Determination 2016/052

Regarding the compliance of a relief drain from the safety valve to a hot water cylinder in a three-year-old house at 890 Levels Store Road, Timaru

Figure 1: Simplified sketch of hot water system

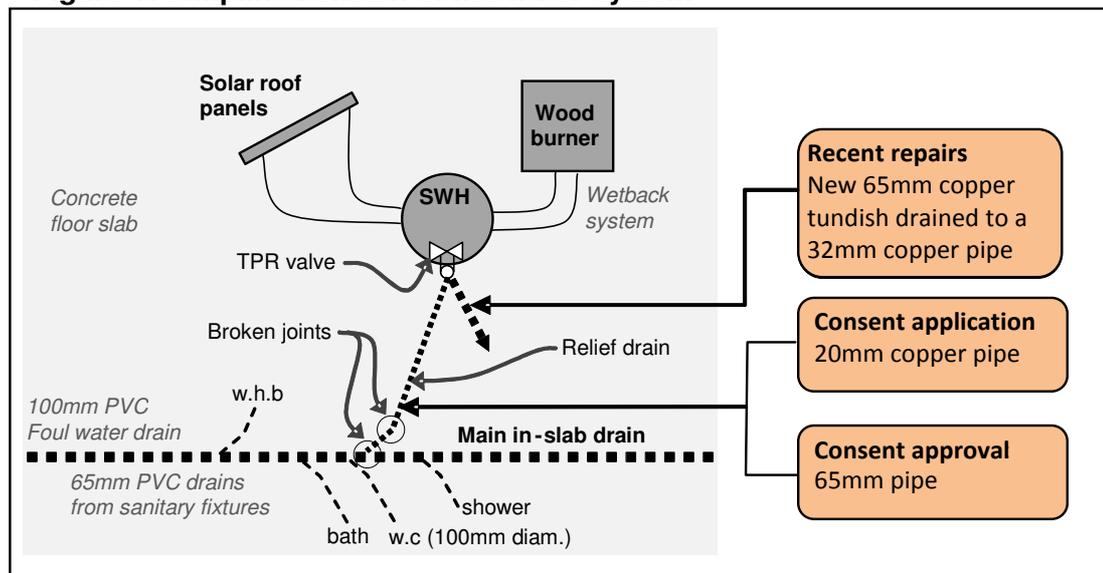
4.4.1 The drainage drawing submitted with the consent application in March 2011 showed a 20mm diameter copper drain line from the TPR valve located under the concrete slab discharging directly into the 100mm diameter foul water drain. The 20mm diameter copper pipe is therefore considered part of the foul water drainage system: AS/NZS 3500.2 requires any foul water drain to be a minimum diameter of 65mm.

- 4.4.3 In July 2011, the drainage plan was revised, at the authority's request, to provide a 65mm diameter foul water drain within the concrete slab, which satisfied AS/NZS3500.2 with respect to the minimum diameter. The revised drainage plan no longer specified copper as the material to be used for the relief drain, though it is reasonable to interpret the plan as calling for PVC given the notation and line style used is identical to the other PVC foul water drains noted on the plan.

- 4.4.4 The original design proposal¹⁴, using a copper pipe, was in accordance with G12/AS1 in respect of the material used, however, the means of discharge into the foul water drainage system was not in accordance with paragraph 6.7.2(d) of G12/AS1, or AS/NZS 3500.2.

- 4.4.5 Given the design and installation of the hot water system, the discharge of high temperature water from the TPR valve into the PVC foul water drain was a very likely occurrence. I am satisfied that the effects of the high temperature water discharging from the SWH via the TPR valve into the PVC drainage system was not taken into account in the design, approval, and installation of the hot water system in this house.

- 4.4.6 The revised drainage plan did not address, and the authority did not request, information regarding potential damage to the foul water drains from the likely impact of high water temperatures from the heating sources to be connected to the SWH.

- 4.4.8 I am therefore satisfied that the SWH TPR valve drain, as consented and as originally installed, did not comply with Clauses B2.3.1(a) and G13 of the Building Code.

2.5.1 The applicant engaged the third plumber to replace the drain from the SWH with a new 65mm copper tundish that drained into a new 32mm copper relief pipe extending under the concrete slab directly to the building exterior.
